Preview Solution CBR-2548-1

Shock Interference With "Z" Springs

Published 20 January 2026

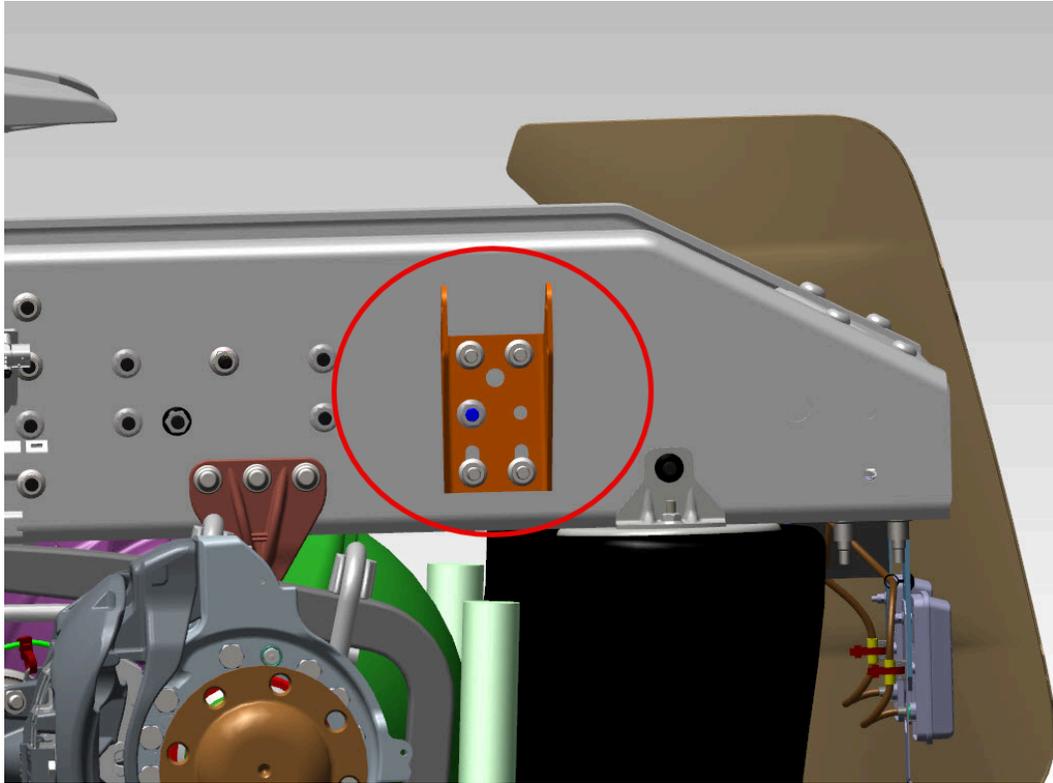
Some vehicles may experience **shock absorber interference with the "Z" springs** on the rear drive axle.

The existing shock mounting bracket may allow insufficient clearance between the shock absorber and the "Z" spring, resulting in contact or interference during suspension movement.

Replace the current shock bracket with the **legacy shock bracket** to give sufficient clearance between the shock absorber and the "Z" spring.

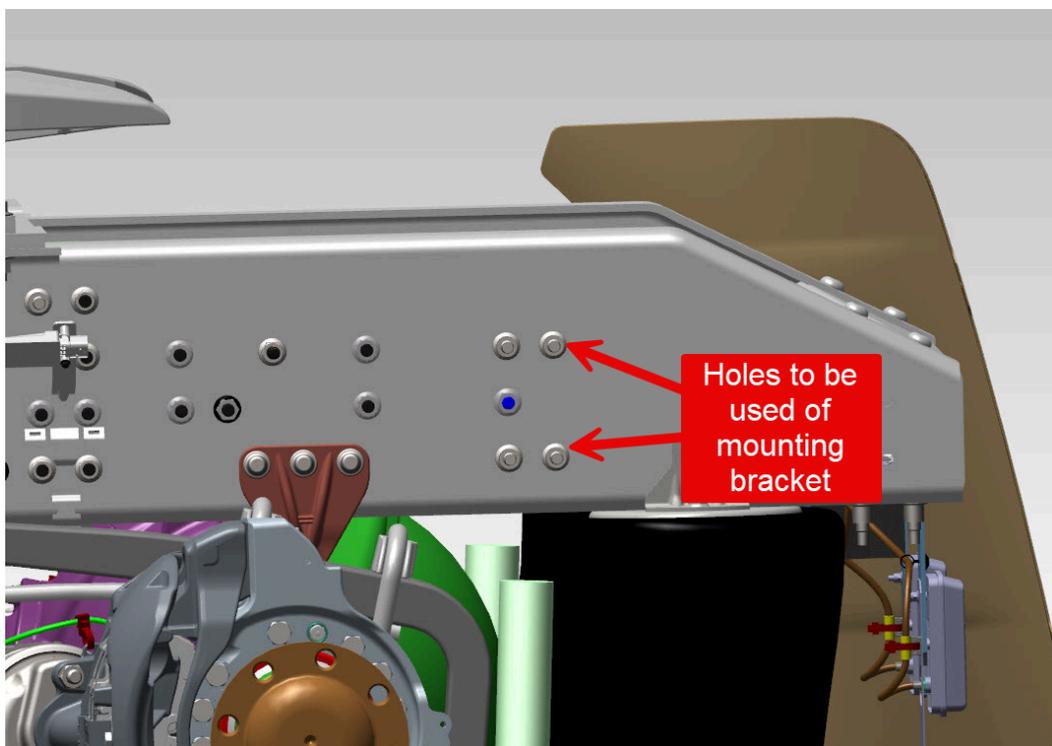
1. Remove the existing shock bracket from the rear drive axle.

2. Install the legacy shock bracket (PN: 23600734) using **two of the four existing mounting holes**.
3. Position the legacy shock bracket in the **two rearmost mounting holes**.
4. **Fill the remaining two unused holes** on each side with huck bolts.

5. Ensure the installed huck bolts **do not interfere with the shock bracket.**
 - If required, **orient the huck bolts inward** to prevent interference.
6. Install shock absorber in the lower mounting hole.
7. Verify proper clearance between the shock absorber and the “Z” spring through full suspension travel
